Village of Arlington Heights

Re: Police Station – Response to Department Comments PC 16-024

Plan Commission Hearing Review Comments- Building Services

Re: Police Station Redevelopment Arlington Heights, Illinois Plan Commission PC #16-024 PUD Amendment to Ord #78-026

LEGEND	
CONCOURSE (Square F	ootage)
CIRCULATION (Square F	ootage)
SUPPORT (Square Foota	age)
FORENSICS (Square Fo	otage)
EVIDENCE (Square Foota	ge)
MULTI PURPOSE (Squar	e Footage)
FIREARMS (Square Foota	ge)

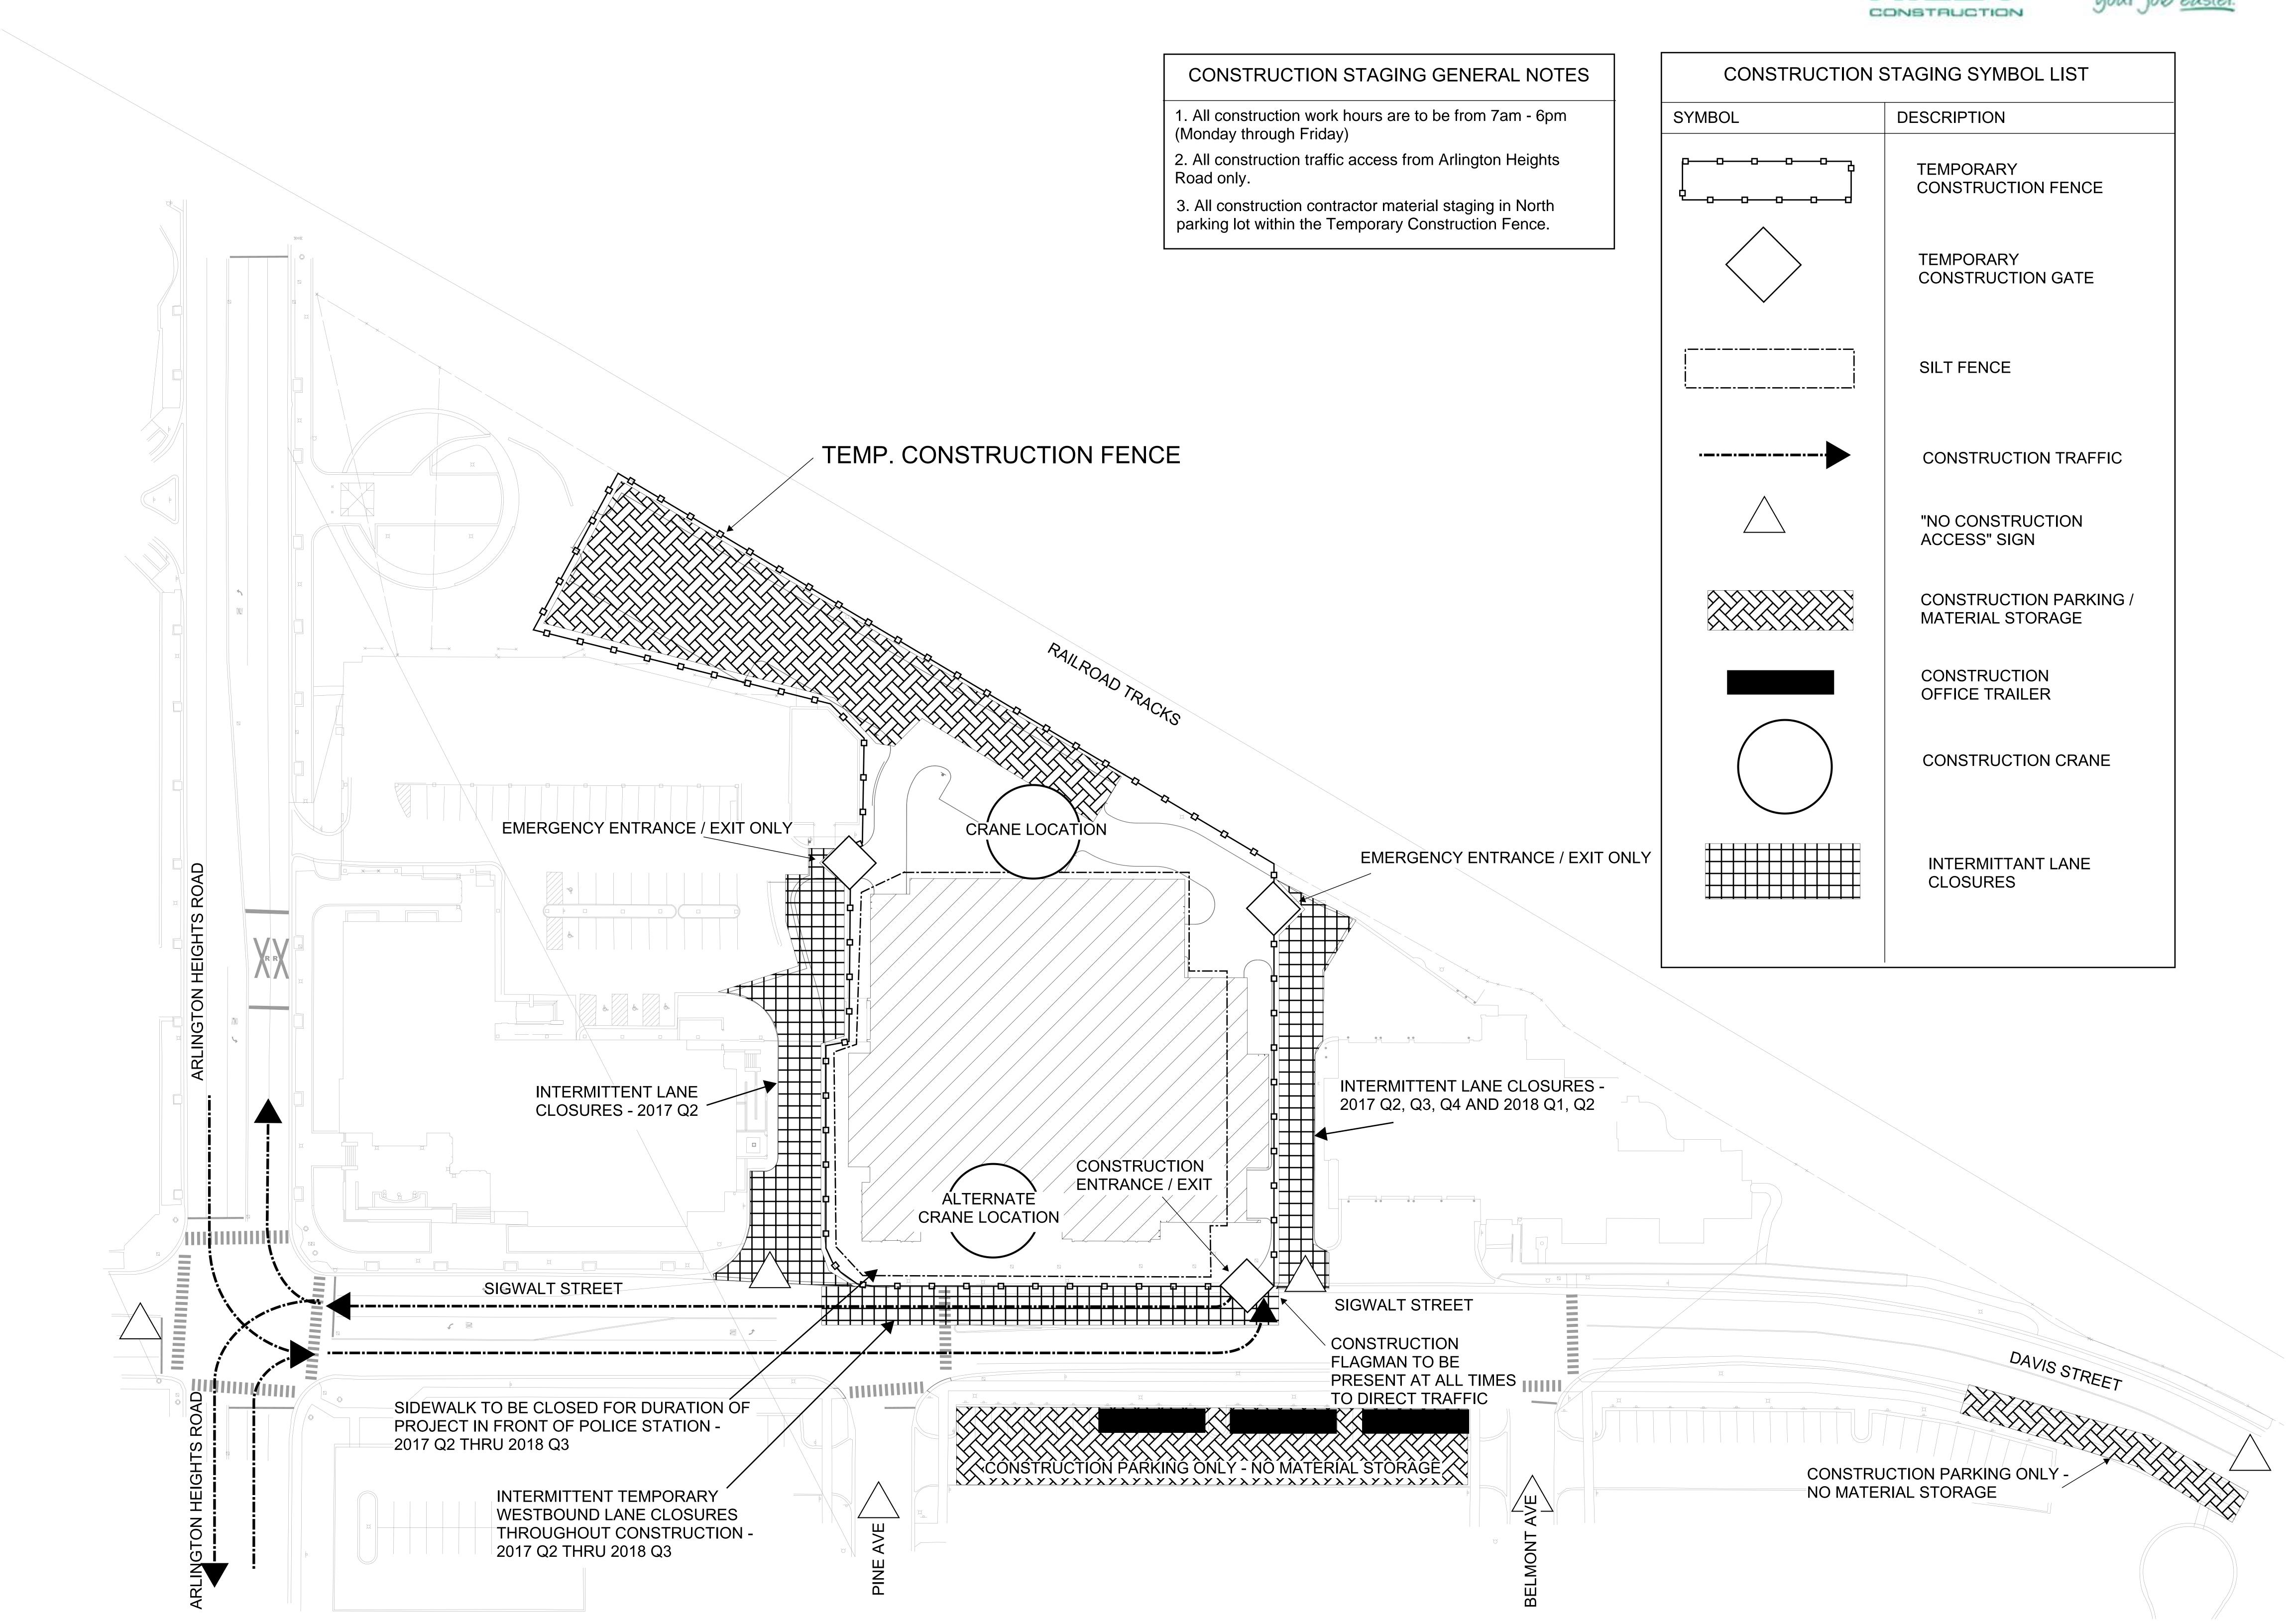
25. Parking requirements could not be calculated as the sizes of the spaces within the proposed Police Station building have not been provided. Please revise the Architectural floor plans to show the square footage of **all** spaces on

The total square footage of the building is consistent and is no greater than 70,000 s.f. As the interiors of the plans are being worked on, as we are in Design Development, there will be some slight modifications so final square footages cannot be provided at this time. We will have this complete by the end of Design Development.

The parking sizes are dimensioned on the floor plans.

AHPD CONSTRUCTION STAGING PLAN

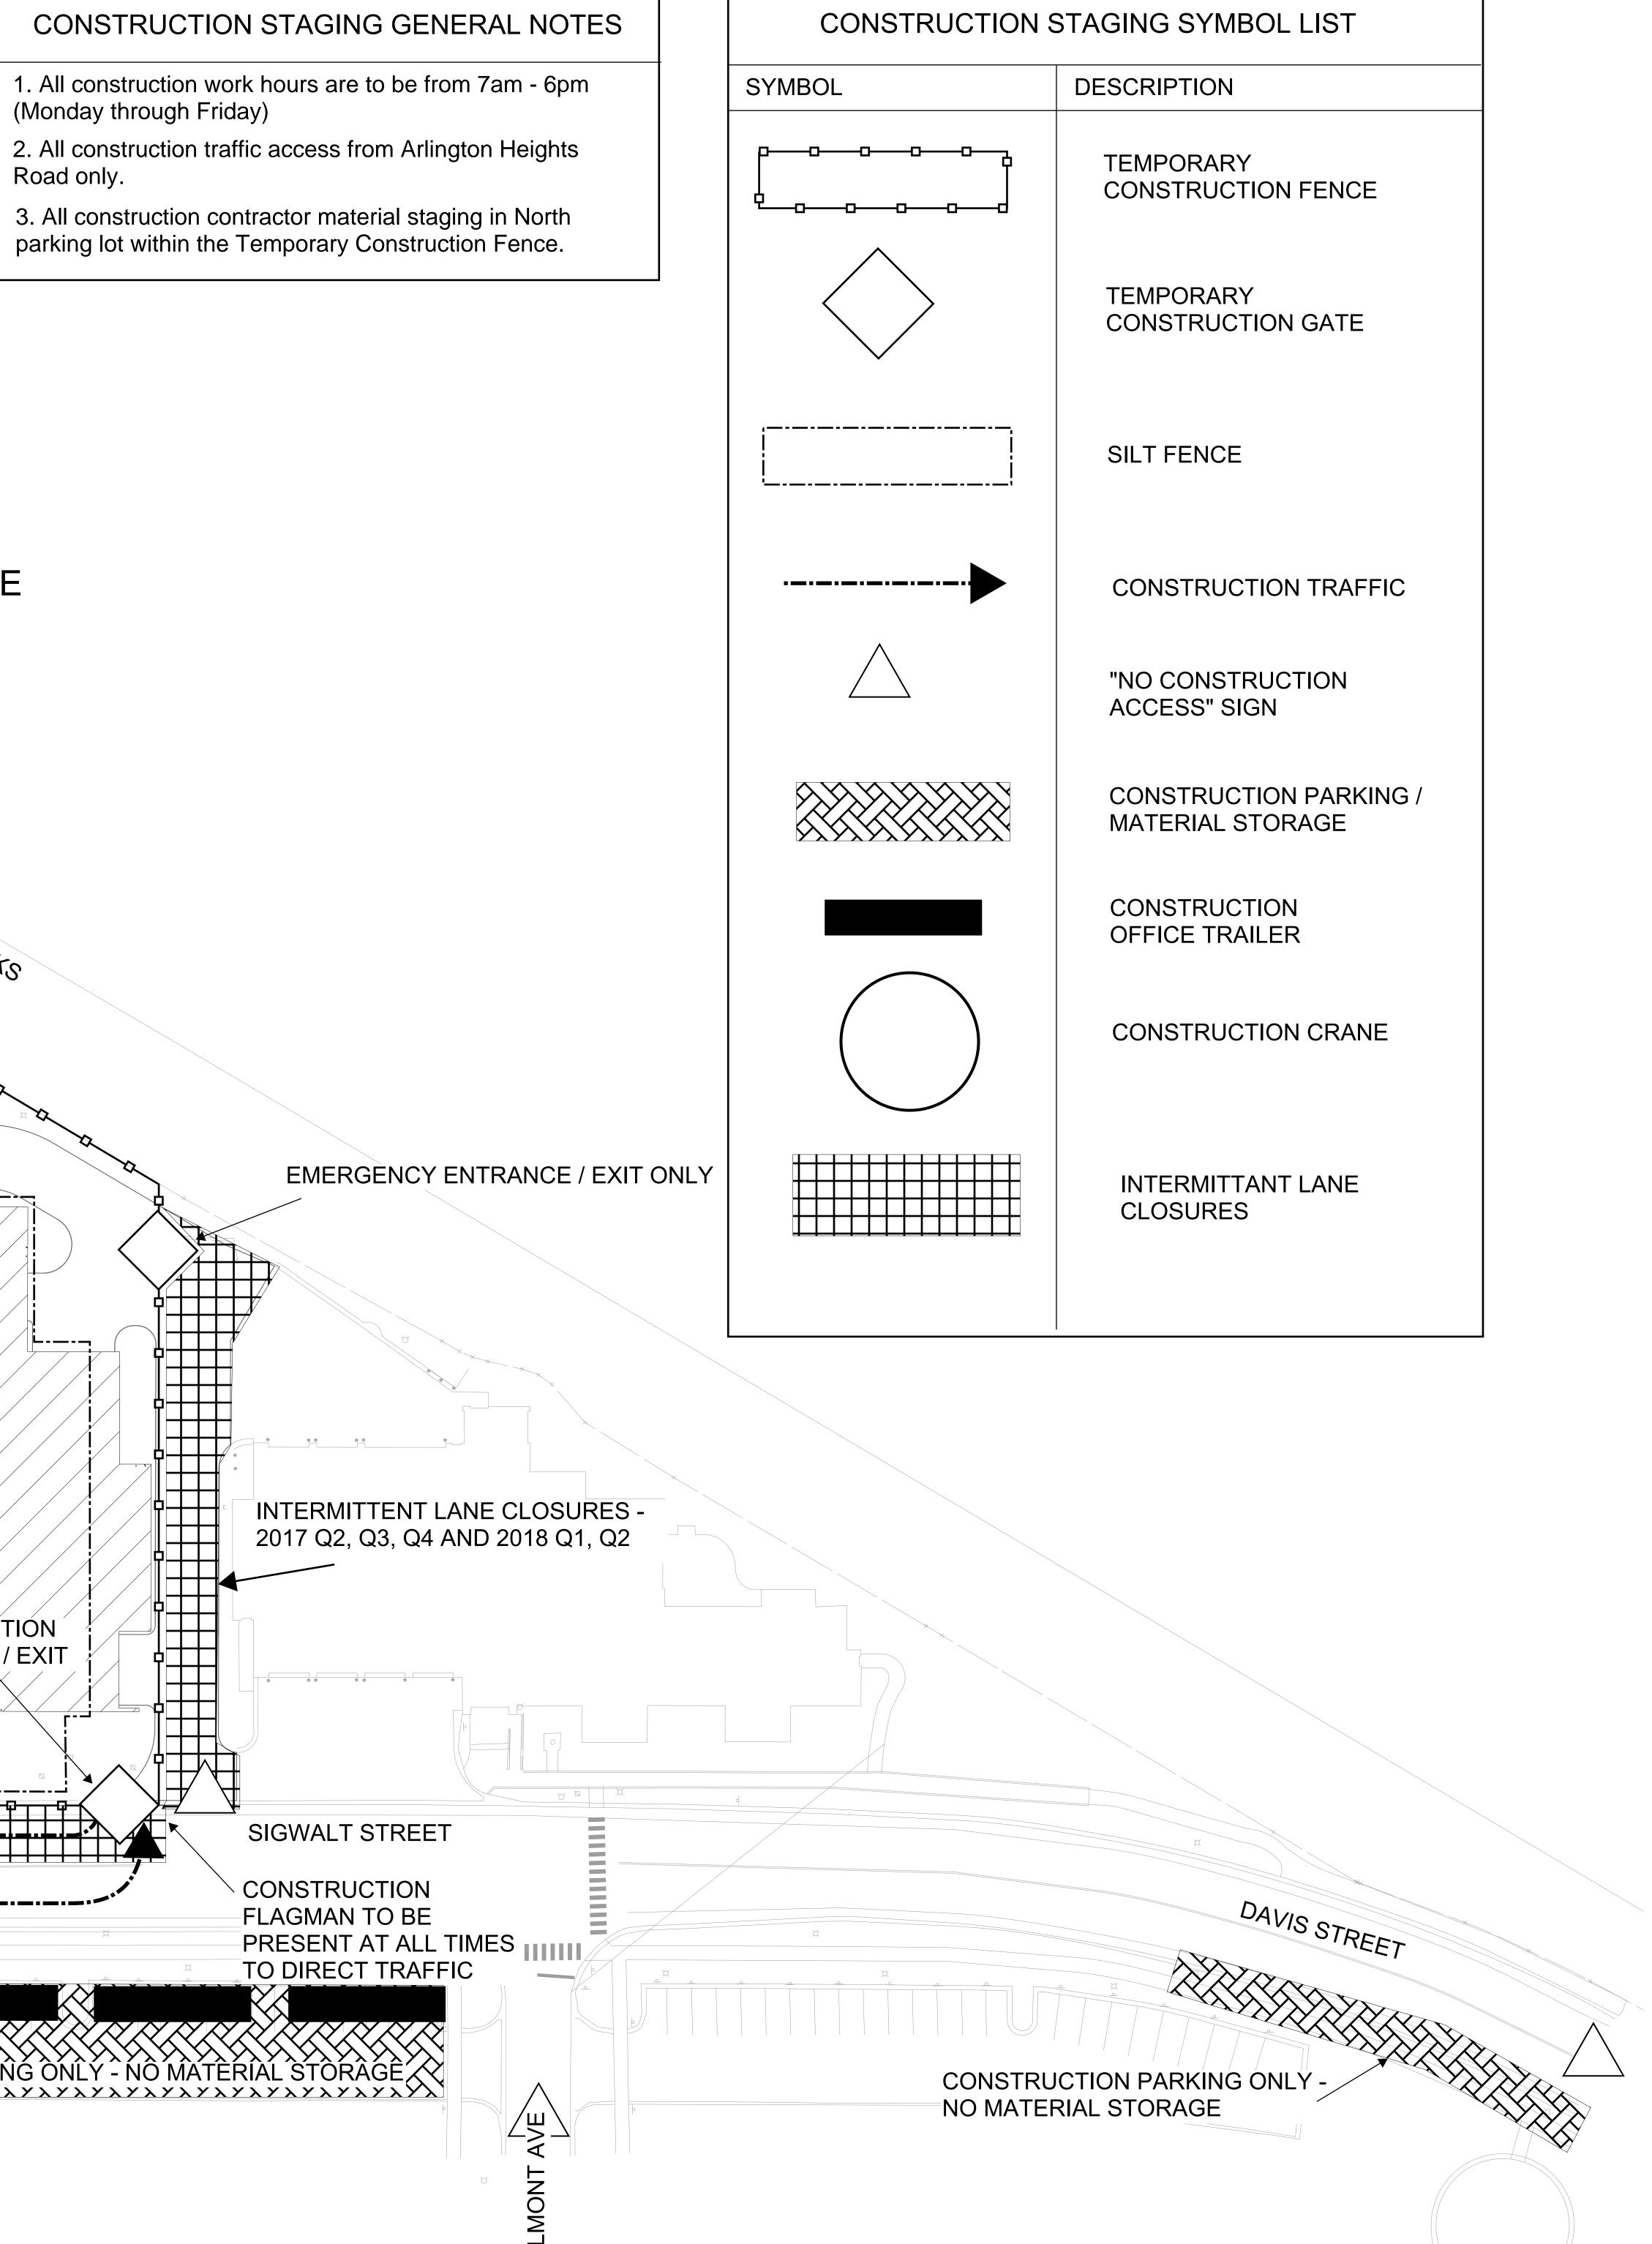
10. Please provide a Development Phasing Plan/Schedule. This schedule shall include the anticipated construction start and completion times for each phase, the anticipated construction sequencing (material delivery schedule, the general construction methodology, construction parking, lane closures including plans illustrating such closures if necessary, etc.).
